SAFETY EVALUATION BY THE OFFICE OF NUCLEAR REACTOR REGULATION

RELAXATION REQUEST FROM ORDER EA-03-009 REGARDING THE

ENTERGY OPERATIONS, INC.

WATERFORD STEAM ELECTRIC STATION, UNIT 3

Figure 1

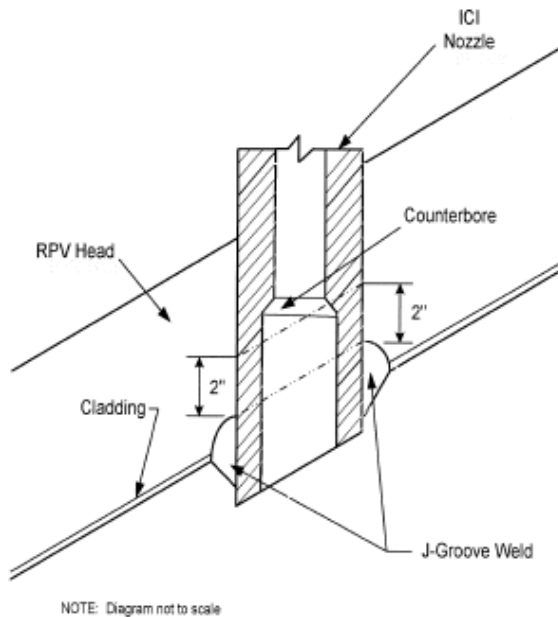
The licensee states that the ICI nozzles are manufactured with a counterbore above the J-groove weld (Figure 1). According to the licensee, because of UT transducer liftoff at the counterbore, a UT blind zone exists at the upper hillside location (180° azimuth) of each ICI nozzle and the blind zone measures approximately 0.88 inch in axial length. The licensee states that the portion of the counterbore blind zone that lies within the required inspection zone of 2 inches above the J-groove weld is centered at the upper hillside location of each nozzle, and is estimated to have a circumferential extent of approximately 135° or less. The blind zone associated with the counterbore does not exist at any other azimuthal location along the circumference of the ICI nozzle within the required 2-inch inspection area above the J-groove weld. The licensee states that the counterbore is significantly closer to the J-groove weld on the upper hillside of the nozzle than on the lower hillside, due to the RPV head angle at the ICI locations. The licensee also states that no volumetric inspection equipment is available to inspect the counterbore region, and resolving the UT limitations due to the counterbore would require eliminating the counterbore region through a physical modification of the nozzle itself.

Within the context of the licensee's proposed alternative examination of the RPV penetration nozzles, the licensee has demonstrated that hardship would result from implementing UT examinations to the counterbore region of the ICI nozzles, associated with modifying the region to allow access by the UT probe to collect data in the counterbore region. The staff finds that the nozzles' counterbore area makes inspection of these nozzles in accordance with Order EA-03-009 difficult and would involve a hardship or unusual difficulty. The licensee proposes to perform a surface examination of the nozzle ID surface 2 inches above the J-groove weld that falls within the blind zone in the counterbore region of all 10 of the ICI nozzles. This evaluation focuses on the issue of whether there is a compensating increase in the level of quality and safety such that these nozzles should be UT inspected despite this hardship.

The staff finds that the licensee's proposed alternative examination of the 10 ICI RPV head penetration nozzles which includes performing a surface examination on the area of material that is not receiving a UT examination per the requirements of Section IV.C.(1)(b)(i) of the Order, i.e., the "blind zone" in the counterbore region, is sufficient to detect the PWSCC phenomenon and therefore provides reasonable assurance of structural integrity of the RPV head, VHP nozzles, and welds. Further inspection of the ICI nozzle counterbore region in accordance with Section IV.C.(1)(b)(i) of Order EA-03-009, would result in hardship or unusual difficulty without a compensating increase in the level of quality and safety.

Figure 2

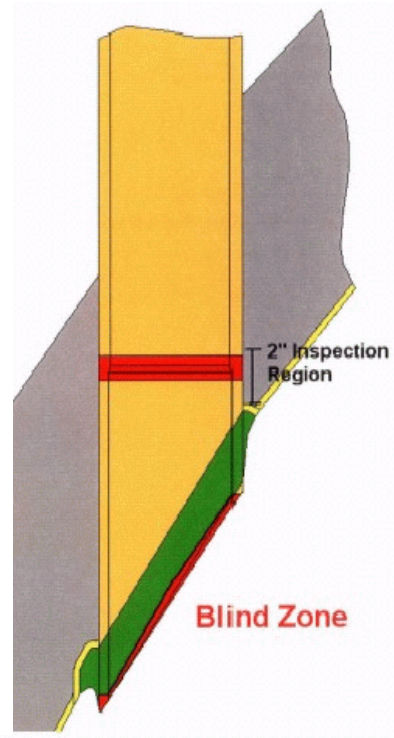
The licensee stated that it will perform a UT examination from the inside diameter (ID) of each ICI nozzle (i.e., nozzle base material) in accordance with Section IV.C(1)(b)(i) of the Order, with the exception of the blind zone at the bottom of each ICI nozzle, and the blind zone in the counterbore region above the J-groove weld of each ICI nozzle. For illustration purposes, Figure 1 shows the ICI nozzle configuration and Figure 2 shows the location of the blind zones. Figure 1 was taken from the licensee's October 24, 2003, letter, and Figure 2 was taken from the licensee's presentation that it gave at NRC headquarters on August 14, 2003.

Entergy states that a blind zone exists along the bottom of each ICI nozzle and varies from approximately 0.20 inch to 0.70 inch. According to the licensee, the blind zone at the end of the nozzle occurs due to loss of coupling as the transducers traverse across the bottom end of the nozzle. The licensee states that this problem is further compounded by the configuration of the ICI nozzle bottom end, which is cut to match the contour of the RPV head. The licensee further states that it is not aware of any equipment currently available that will resolve the configuration limitation.

The staff finds that by performing a surface examination on the area of material that is not receiving a UT examination per the requirements of Section IV.C.(1)(b)(i) of the Order, i.e., the "blind zone" at the end of nozzle, the licensee is performing an examination that is sufficient to detect the PWSCC phenomenon. The staff also notes that the augmented inspection covers the entire wetted surface of the volume of material at the bottom of the nozzle that is not
